**RM 220265: RESPONSE TO RFI REQUEST FOR FAR FETCHED LTD**

**CLIENT: THE WELLINGTON COMPANY**  
**ADDRESS: 189 SIMS RD, TE HORO BEACH**  
**PROJECT: RURAL COHOUSING**  
**RESOURCE CONSENT DRAWINGS**

# **Land Matters Updated Engineering Report**

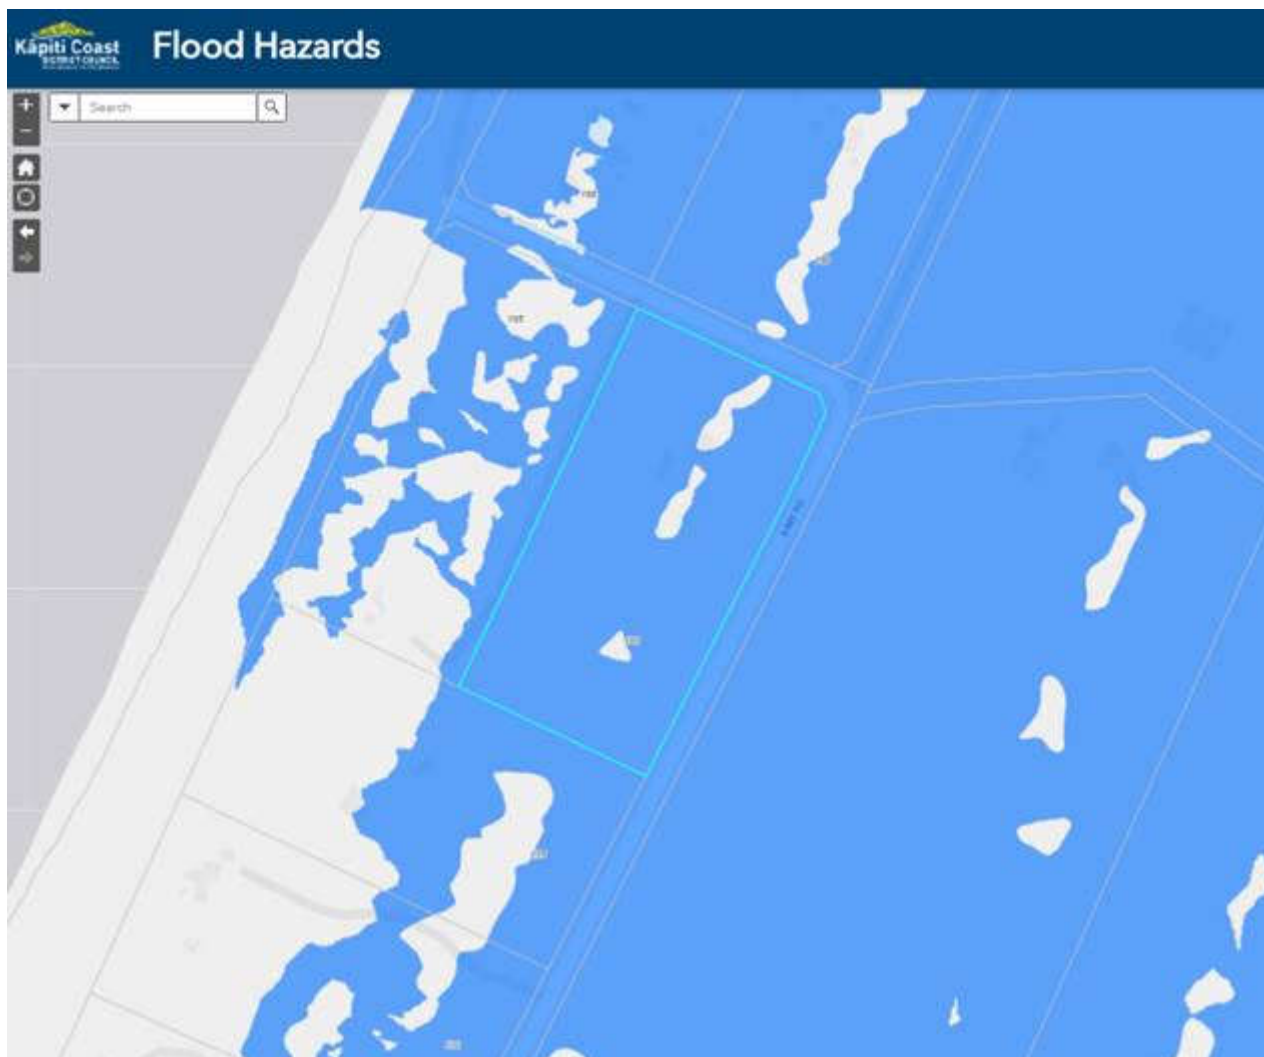
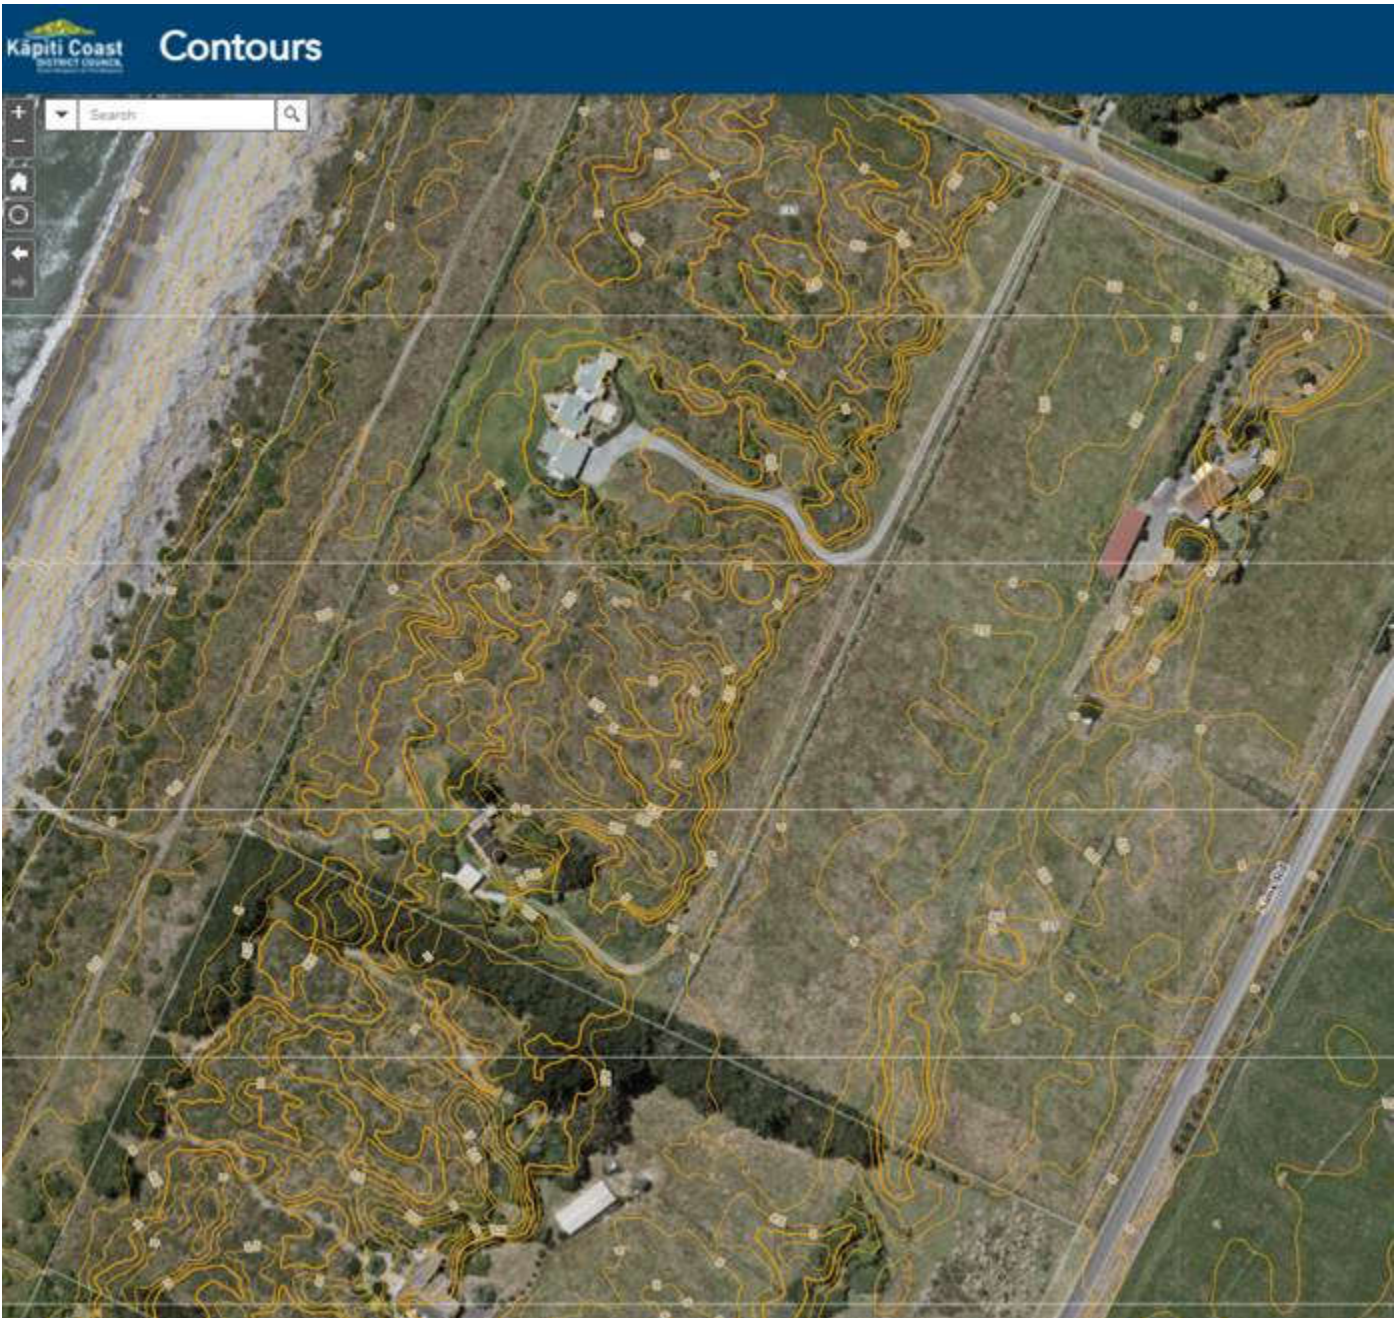
You mentioned in your email back in April that your model for the Mangaone Stream was currently in draft form and could be subject to change. Can you please advise me of the following:

- Whether the Mangaone Stream model has been finalized and if so what the new model's base flows are through this area; **The model has not been finalized, but the draft extents are fairly similar to what was modelled previously.**

- I understand you have a new 'Regional Flood Exposure Model' that combines river and local stormwater flooding – do you have this available for this site? **The Regional Model is intended to show areas which may be exposed to flooding and can be used where we do not have more detailed information on the flood hazard. The draft Mangaone model is the best available information we have for this property.**

You identified the 1% flood level through the site at RL 5.3m. According to LiDar data, the site levels range from RL 5.5m (the higher areas through the middle of the site) to between 3.4 and 4m in the remainder of the site and so the site is identified as being inundated from ponding by between 1.7m and 1.3m in depth.
